1.0 APPLICATION SUMMARY

Applicant: RVI Planning & Landscape Architecture
 FLU Category: RES-12
 Service Area: Urban
 Site Acreage: +/-80.9 acres
 Community Plan Area: Ruskin
 Overlay: None
 Request: Minor Modification to PD 21-1335

Proposed PRS 25-0091: The proposed minor modification requests to modify Condition 3.5.d relating to garage projections and Condition 3.5.a relating to driveway locations.

PETITION NO: PRS 25-0091

2.5 Proposed Site Plan

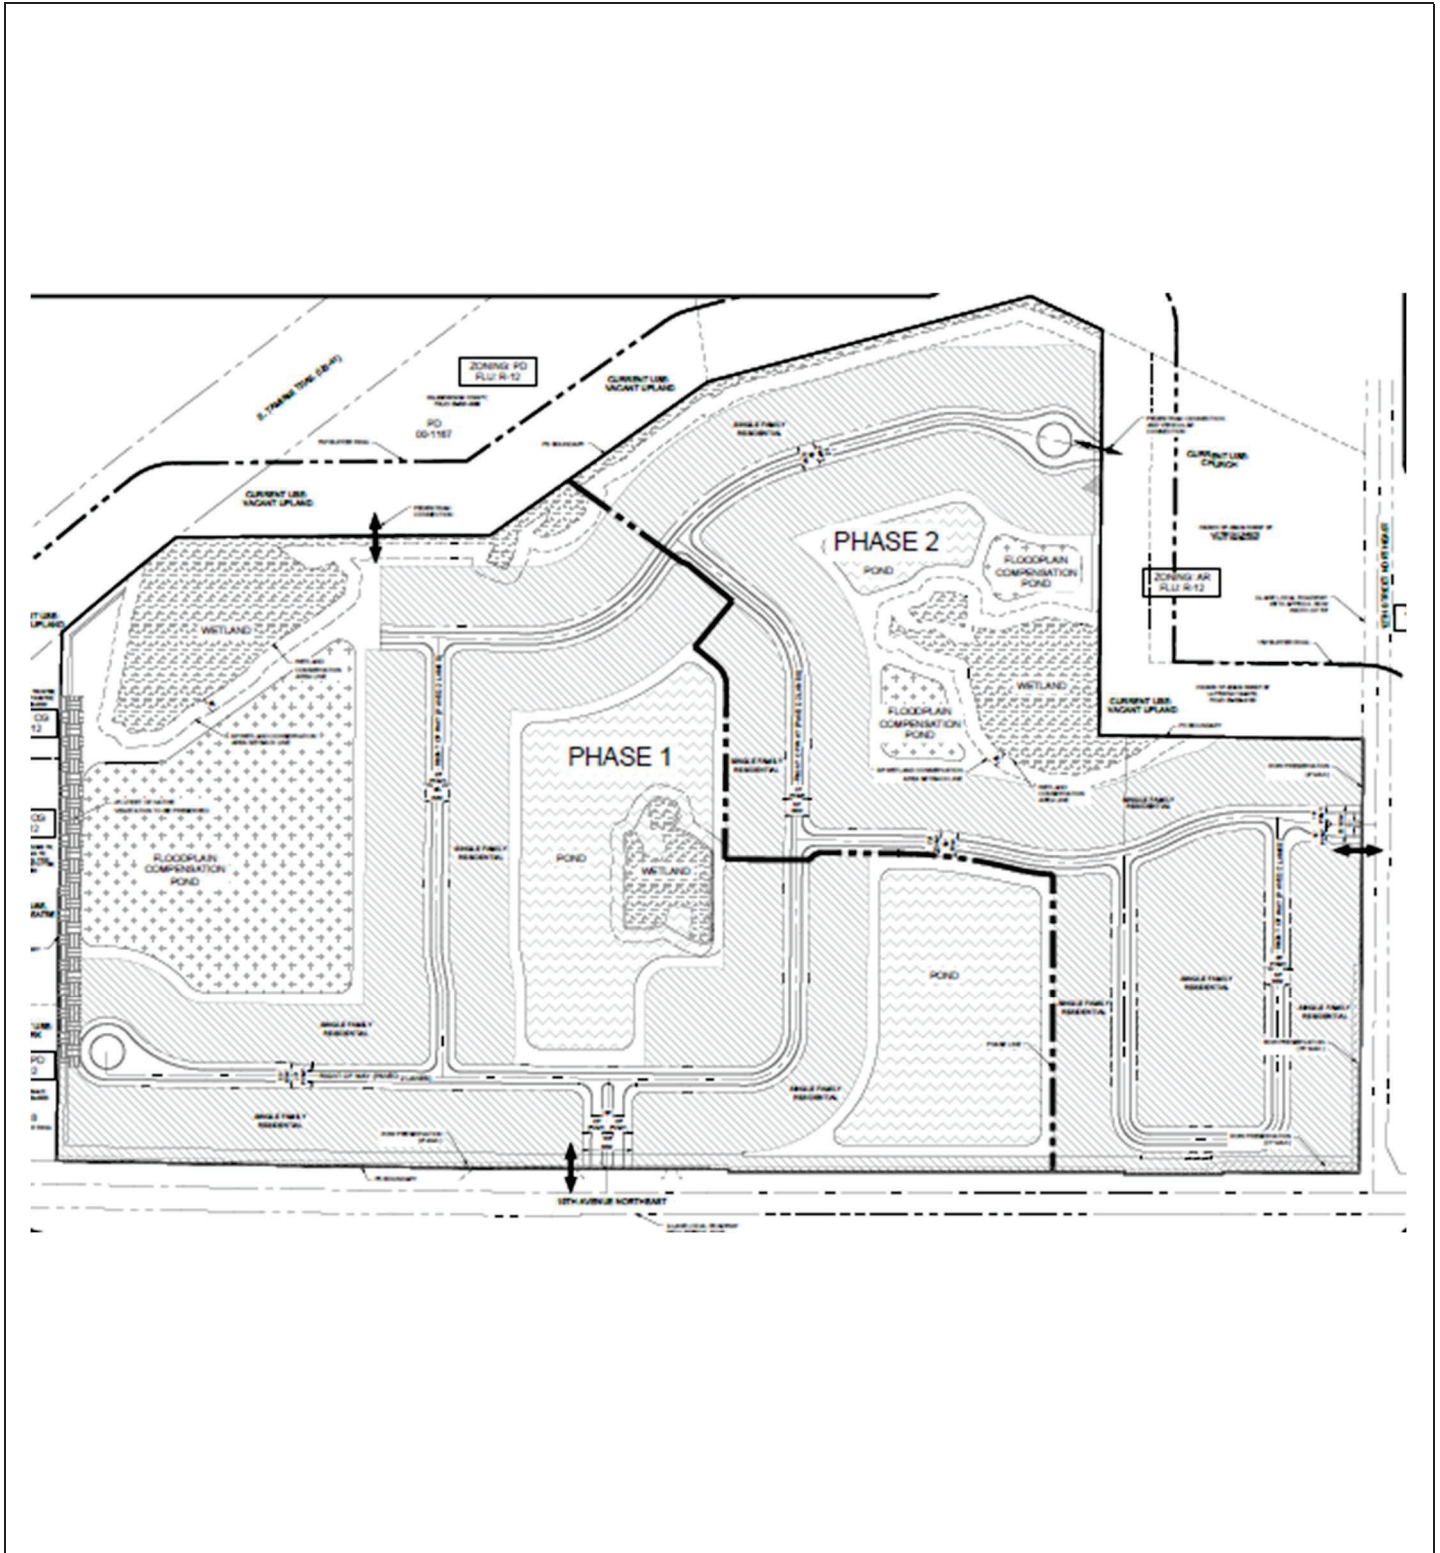
- (1) Modify Conditions 3.5.a to allow a waiver of the alternating driveway patterns on lots adjacent to drainage easements or utilities.
- (2) Modify Condition 3.5.d to allow the garage to be located at a setback lesser than the entry/ façade setback and require that the front entry feature shall be roofed and feature a minimum of one decorative column.

The applicant provides reasoning for the proposed condition modifications. The applicant states that Condition 3.5.d set maximum limitations on the projection of garages and entry features to avoid unattractive architecture, commonly referred to as “snout houses” where the garage is the predominant feature from the street view. The applicant proposes to allow the front porch to be located at a setback that exceeds the garage façade setback, but still subject to the 20-foot setback. Additional requirements for architectural enhancements include providing a roof covering the entry feature, as well as at least one (1) decorative column. Further, the applicant states that the proposed condition revisions ensure attractive architectural views from the street.

The second applicant proposed condition revision is regarding Condition 3.5.a which provides a design standard whereby driveways are required to be provided in an alternating pattern on the left or right side of the frontage. The intention of this provision was to create for variability in front façade design. However, this requirement may be adjusted for corner lots. The applicant proposes to allow for adjustments to this requirement to be considered for lots adjacent to drainage and utility easements. The applicant’s justification for the request includes to allow for better drainage flow as well as maintenance of drainage and utility easements by preventing proximity of driveways to such easements.

Based upon the above considerations, staff finds the request is **APPROVABLE, subject to conditions.**

FIGURE 1
ACCESS IMPROVEMENTS

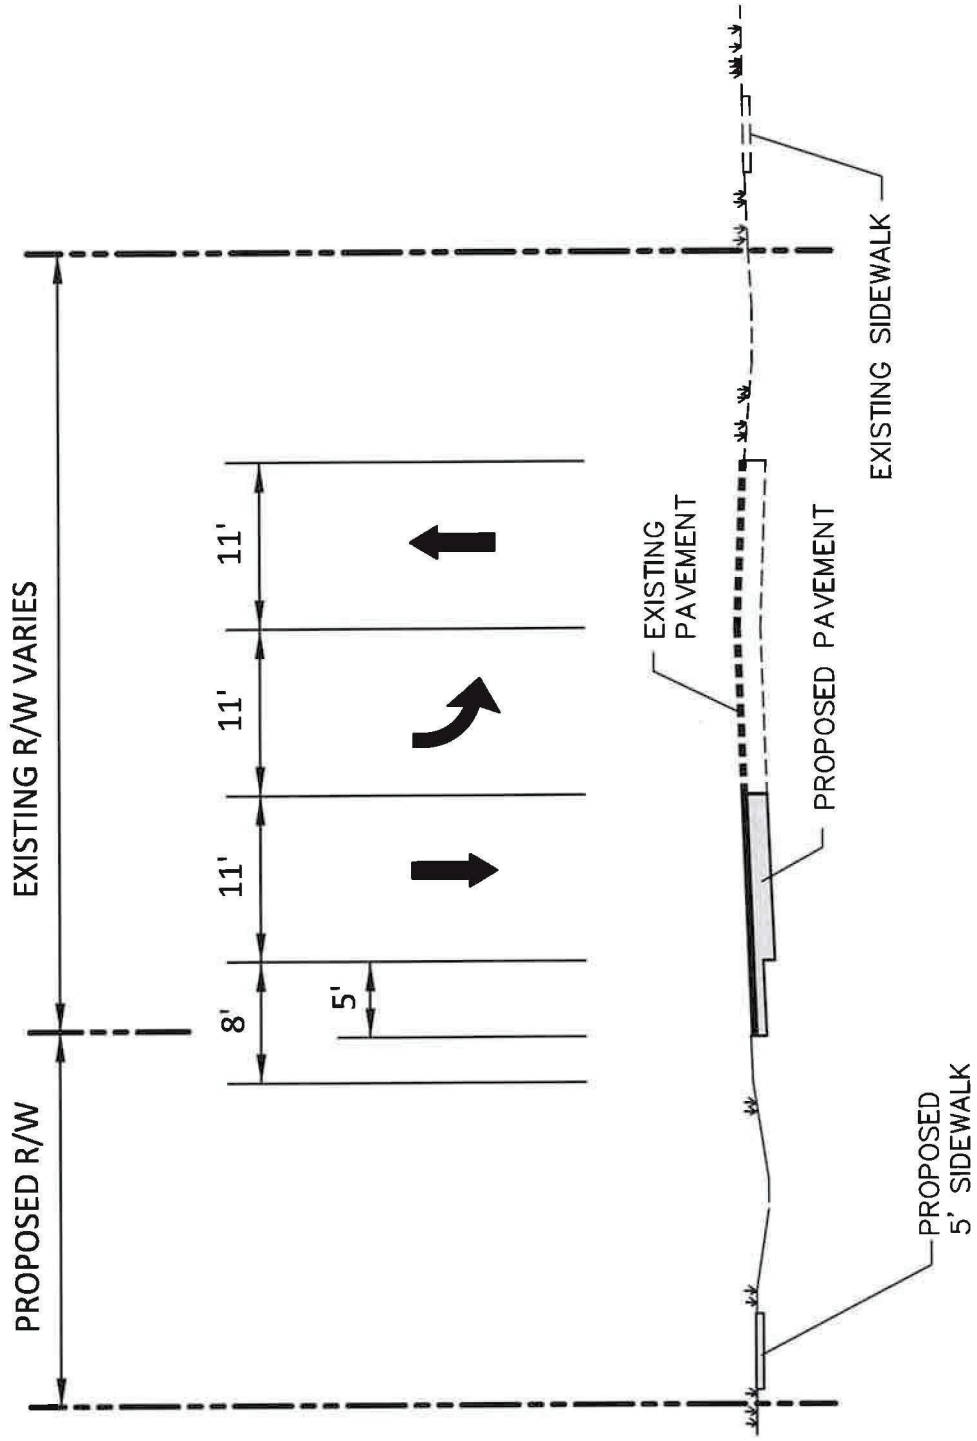
1. There is limited right of way on the east side of 12th Street.
2. The developer proposes the following improvements:
 - a. Extend the southbound left turn lane on 12th Street at 19th Avenue to the proposed project access.
 - b. Add on 8 foot shoulders with 5 foot paved (bike lanes) from 19th Avenue to the northern property line on the west side of 12th Street.
 - c. Construct 5' sidewalk on the west side of 12th Street from 19th Avenue to the northern property line.

Figure 1 illustrates the limits of the proposed improvements and Figure 2 illustrates the proposed Typical Section.

No changes to this Design Exception were proposed by the applicant. The County Engineer found the requested zoning changes will have no effect on this Design Exception. As such, the County Engineer will approve a de minimis exception to the previously approved Design Exception in the event PRS 25-0091 is approved.
